Focused Technical Review: July 2019 Merced Subbasin Draft Groundwater Sustainability Plan (GSP)

**Figure 1 - Representative Monitoring Network for GW Levels Relative to Domestic Wells, DACs, and Community Water Systems
Merced Subbasin**

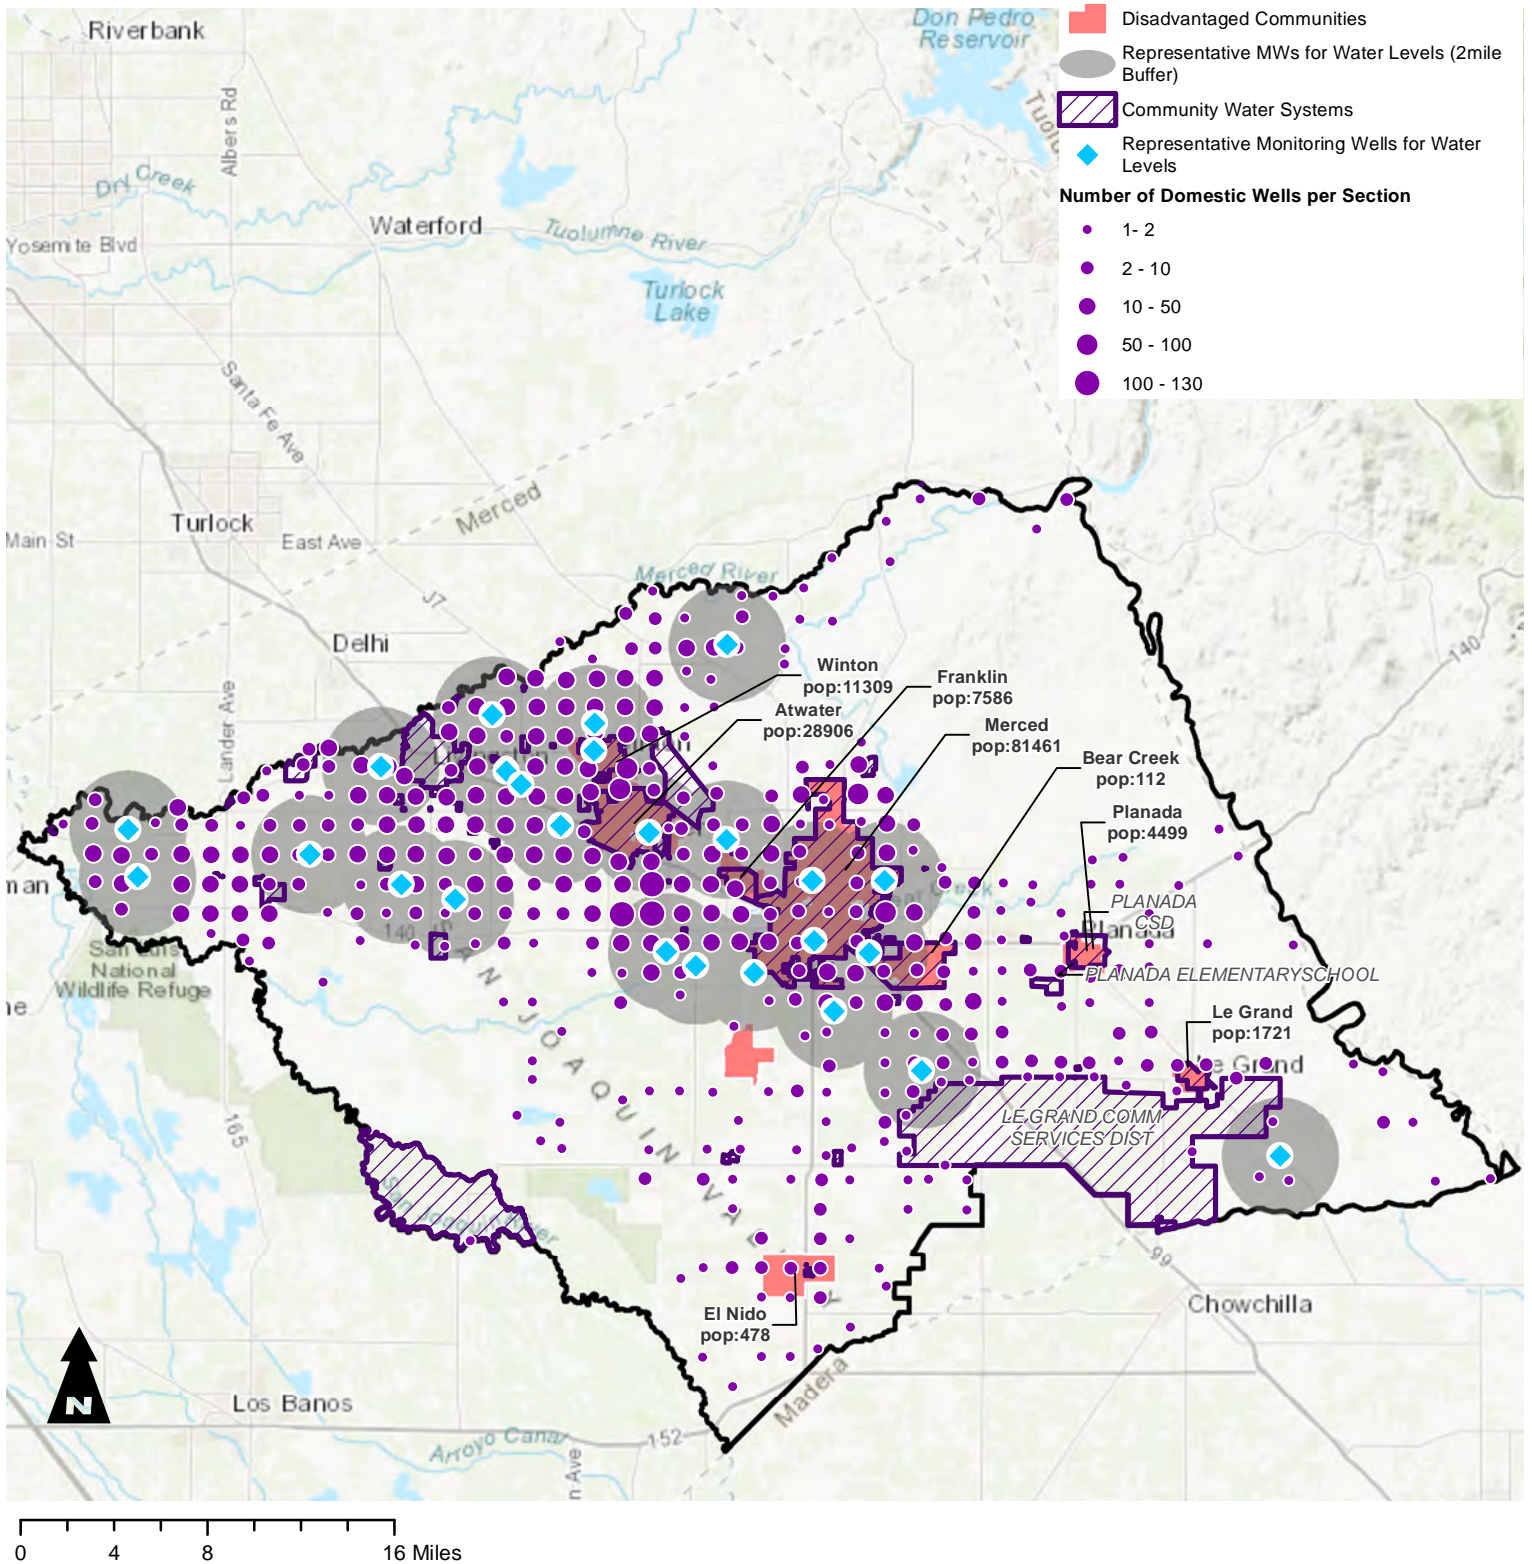
- Given the limited spatial distribution of the RMW network, a substantial proportion of domestic wells within the subbasin appear to have not been considered in the development of these MTs. **Figure 1** shows the location of domestic wells within the subbasin. Each dot is scaled to represent the number of wells located within a given PLSS Section (i.e., approximately a 1-square mile grid cell). Based on this assessment, approximately 1,100 out of approximately 3,600 domestic wells in the subbasin are located outside of the two-mile radius areas used to establish these MTs. **Nearly one-third of all domestic wells in the subbasin were therefore not considered in the establishment of MTs.**

- The RMWs are generally located in the center of the subbasin, while domestic wells are distributed widely across the subbasin. In particular, as shown in **Figure 1**, the domestic wells located in and around the DACs of El Nido, Planada, Le Grand, and south of the City of Merced are located outside of the areas being monitored for water levels. **As such, there are no water level RMWs, or SGMA compliance points, for water levels in the vicinity of these beneficial users.**

- **Figure 1** also shows the location of community water systems in the subbasin. As you can see in this figure, the **RMW network does not provide adequate coverage for the Planada Community Services District (CSD), Planada Elementary School, or Le Grand CSD; combined, these systems serve a population of over 6,800 people.**

- In order to improve the RMW network, we recommend that additional *representative* monitoring wells (with MTs) be established to be protective of the DACs of Planada, El Nido, and Le Grand.

**Figure 3 - Representative Monitoring Network for Water Quality Relative to Domestic Wells, DACs, and Community Water Systems
Merced Subbasin**

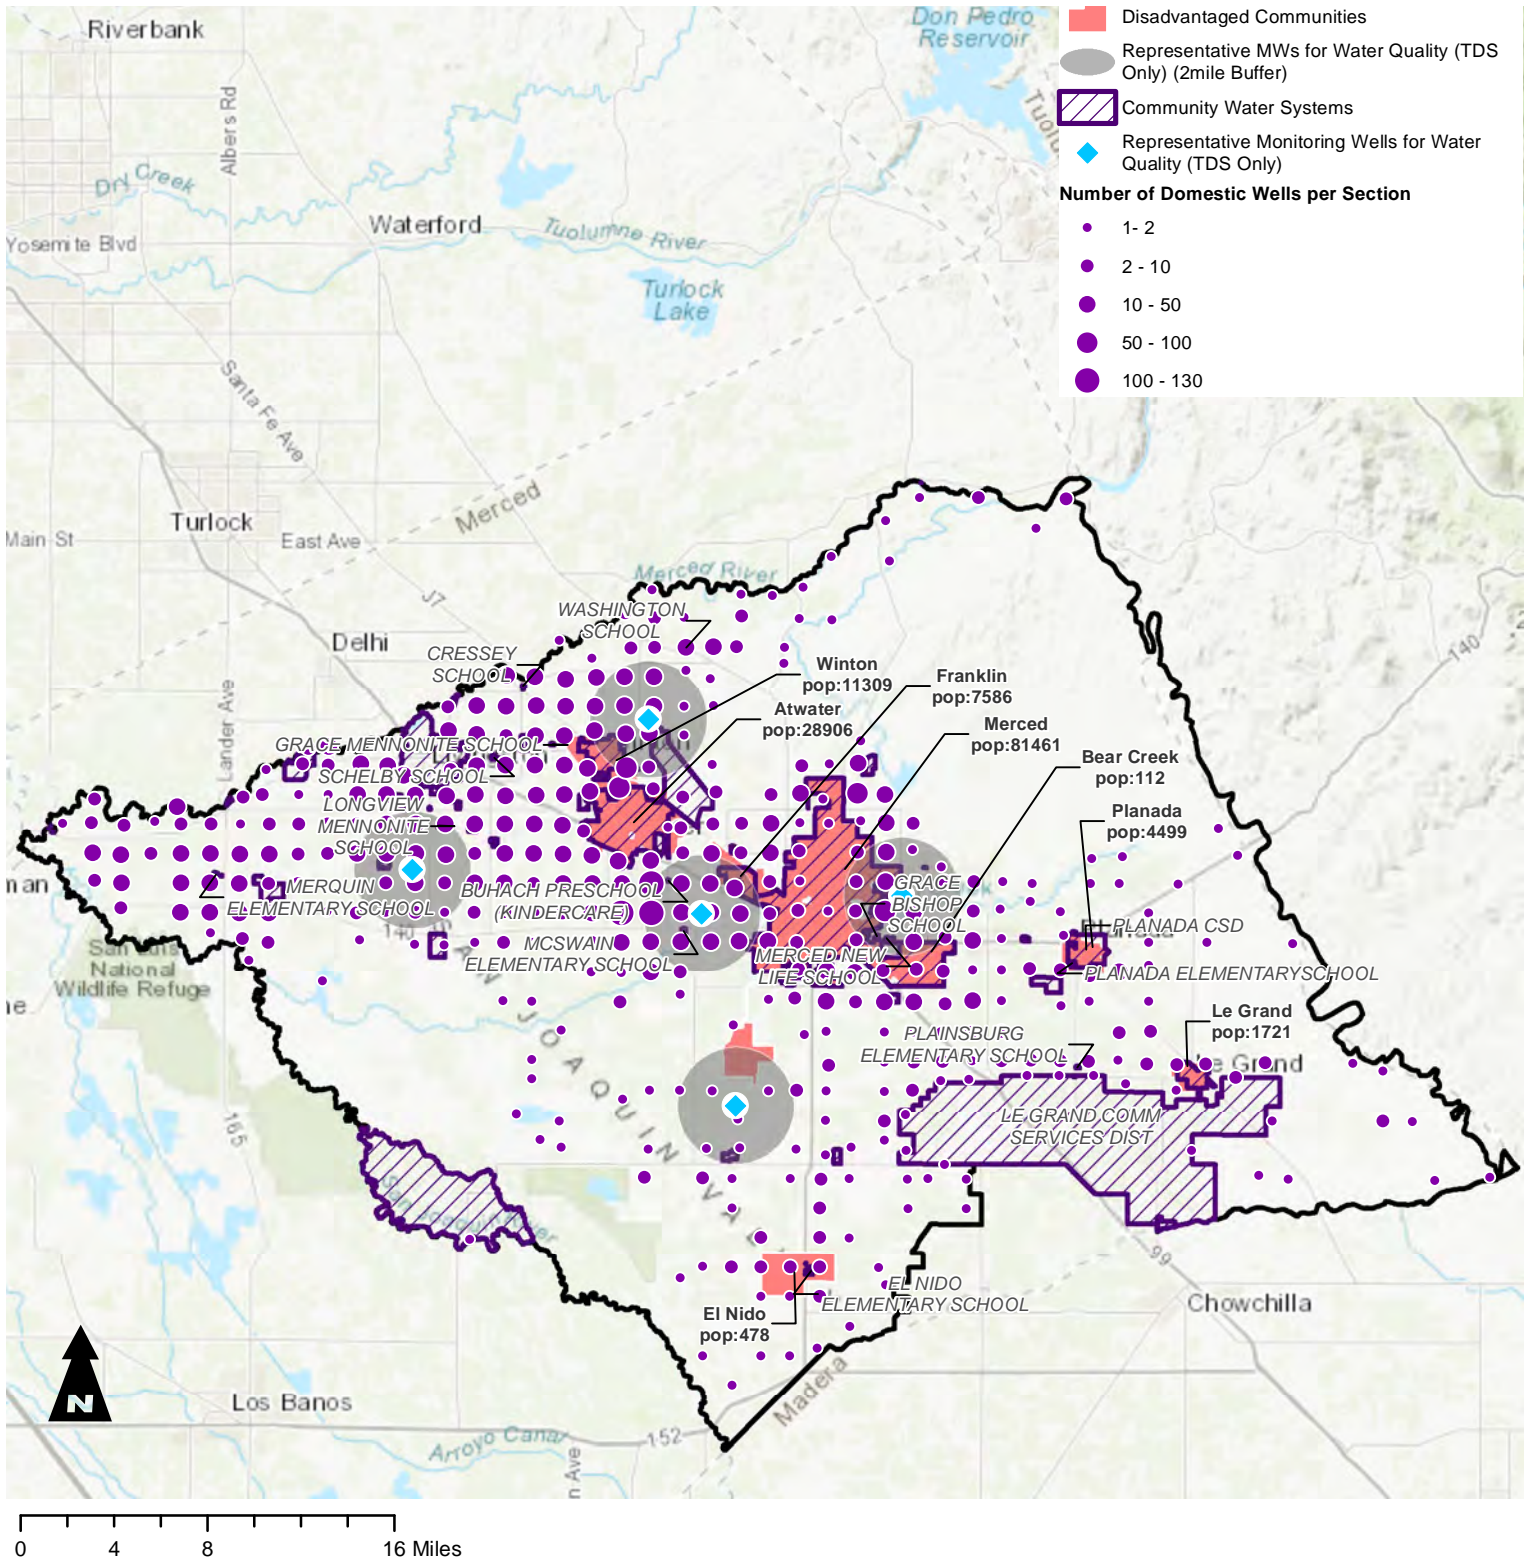
- **Figure 3** shows the location of domestic wells within the subbasin. Each dot is scaled to represent the number of wells located within a given PLSS Section (i.e., approximately a 1-square mile grid cell). **Figure 3** also shows the location of the five water quality RMWs. Over 2,600 out of 3,600 domestic wells in the subbasin are located outside of a two-mile radius of these RMWs. **Over 70% of all domestic wells in the subbasin are therefore located more than two miles from RMW locations where water quality sustainability will be evaluated against MTs.**

- As shown in **Figure 3**, nearly 70 community water systems are located in the subbasin, most of which are located far from the water quality RMWs, including Planada CSD, Le Grand CSD, and many systems supplying schools in the area. The proposed water quality representative monitoring network appears to be inadequate for measuring and quantifying the sustainability of

the groundwater resource for these systems. The GSP explains that community water systems are required to conduct periodic water quality monitoring on their systems; however, this does not prevent the systems from being impacted by degraded water quality resulting from groundwater use and management actions in the subbasin. **At a minimum, the draft GSP should explain how the data from the community water systems will be incorporated into subsequent GSP evaluations and decisions. Further, the draft GSP should describe how the proposed RMWs will ensure that the groundwater used by these community water systems will be managed to avoid significant and unreasonable negative water quality impacts to these beneficial users.**

- In order to improve the monitoring network for water quality, we recommend that additional *representative* monitoring wells (with MTs) be established to be protective of the DACs of Planada, El Nido, and Le Grand, as well as in the western portion of the subbasin.
